# Technical Service Bulletin

## 58D5 UPDATE – Servicing Child Lock (NVLW)

November 6, 2018

Model(s)	Year	VIN Range	Vehicle-Specific Equipment
A5 Sportback	2016 - 2017	See Campaign/Action screen in Elsa	See Campaign/Action screen in Elsa

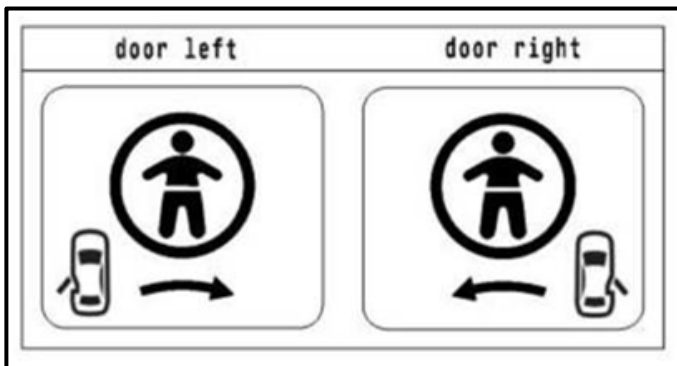
- The embossed symbol for activating the child lock may be reversed. As a result, the child lock cannot be activated in the direction shown by the embossed symbol on the door.

On Audi A5 Sportback vehicles with manual child lock manufactured within a specific period, the embossed symbol for activating the child lock may be reversed. As a result, the child lock cannot be activated in the direction shown by the embossed symbol on the door.

Perform the following procedure on **both** rear doors.

- Open a rear door.
- Turn the child lock in the direction indicated on the symbol on the door.
- Shut the door and try to open the door from the inside.
- If the door will not open using the inside door handle with the child lock turned in the direction indicated on the existing symbol, no further work is required to the door being tested.
- If the door opens using the inside door handle a new label must be installed over the existing child lock symbol.
  - Clean the area as necessary to remove any dirt or debris.
  - Choose the appropriate label based on which door is affected.
  - Ensure minimal air bubbles are created when installing the new label.
